DESIGN <i>PH</i>	DRAWN BY <i>B</i>	DART AEROSPACE LTD HAWKESBURY, ONTARIO, CANADA	
CHECKED <i>PH</i>	APPROVED <i>PH</i>	DRAWING NO. D3303	REV. B SHEET 1 OF 4
DATE 06.08.17		TITLE HEAD REST	SCALE 1:3
REV	DATE	DESCRIPTION	
A	04.08.18	NEW ISSUE	
B	06.08.17	UPDATED FLAT PATTERN TO FORM PART IN ONE OPERATION USING OFFSET DIE

**D3303-041 HEAD REST**

DRAWING NO. D3303	TITLE HEAD REST	REV. B	DART AEROSPACE LTD ENGINEERING ORDER		D.E.O. NO. D3303-B-1	SHEET NO. SHEET 1 OF 1	SCALE NTS
DRAWN AJS	CHECKED <i>[Signature]</i>	MFG. APPR. <i>[Signature]</i>	APPROVED <i>[Signature]</i>		DE APPR. <i>[Signature]</i>		
DATE 08.10.15	DATE 08.10.15	DATE 08/10/16	DATE 08/10/16		DATE 08/10/16

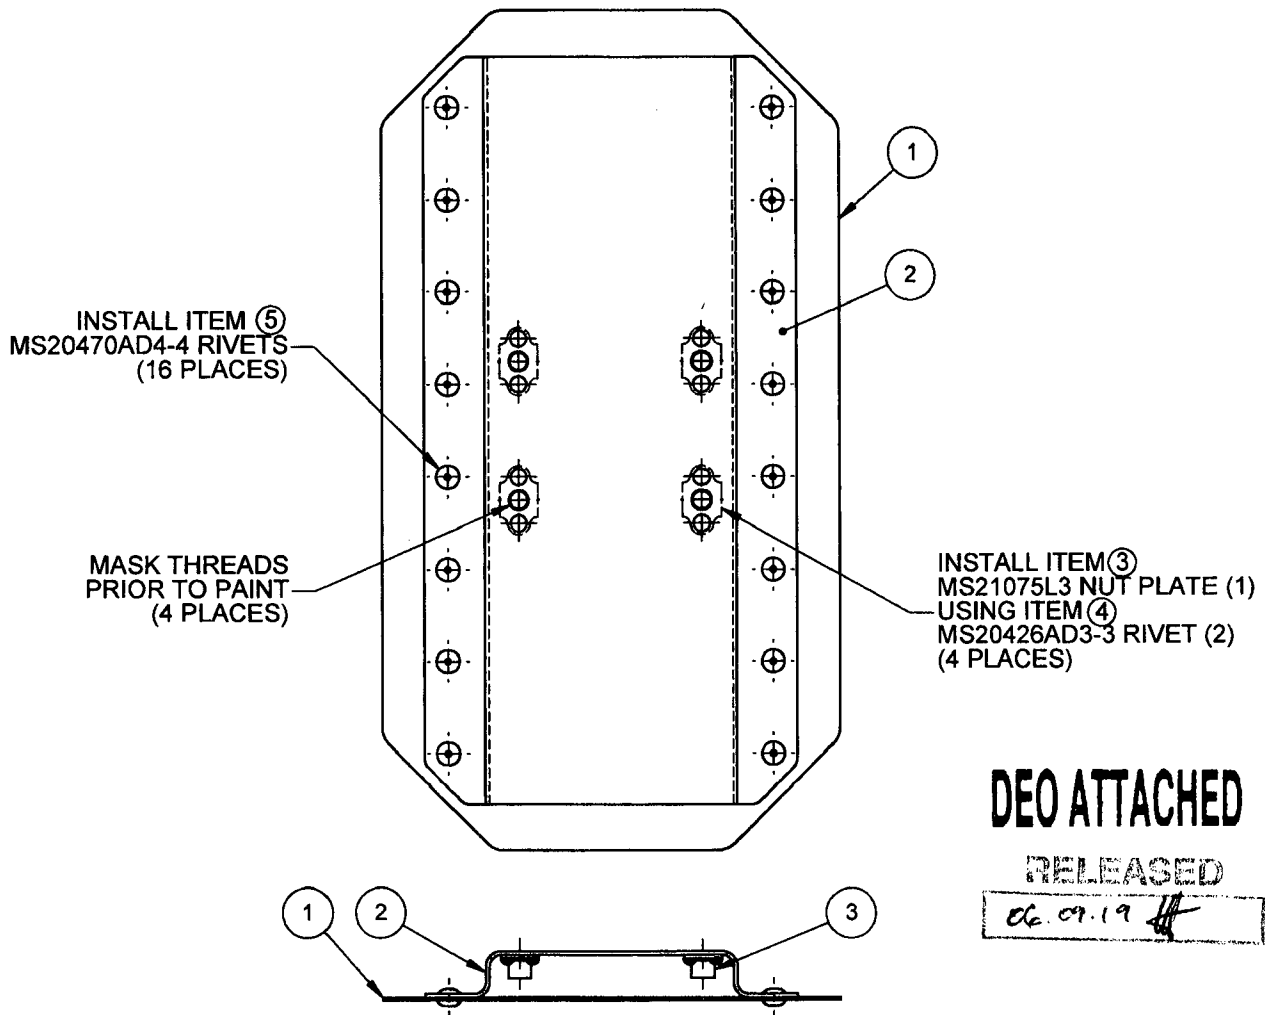
SHEET 1 ADD 1300L ADHESIVE BY 3M TO NOTE 1 AS FOLLOWS:

- 1) BOND D3305-1 FOAM TO D3303-043 BRACKET ASSEMBLY USING 3M 1300 OR 1300L ADHESIVE (0.002" TO 0.010" THICK) IN ACCORDANCE WITH MANUFACTURER'S INSTRUCTIONS
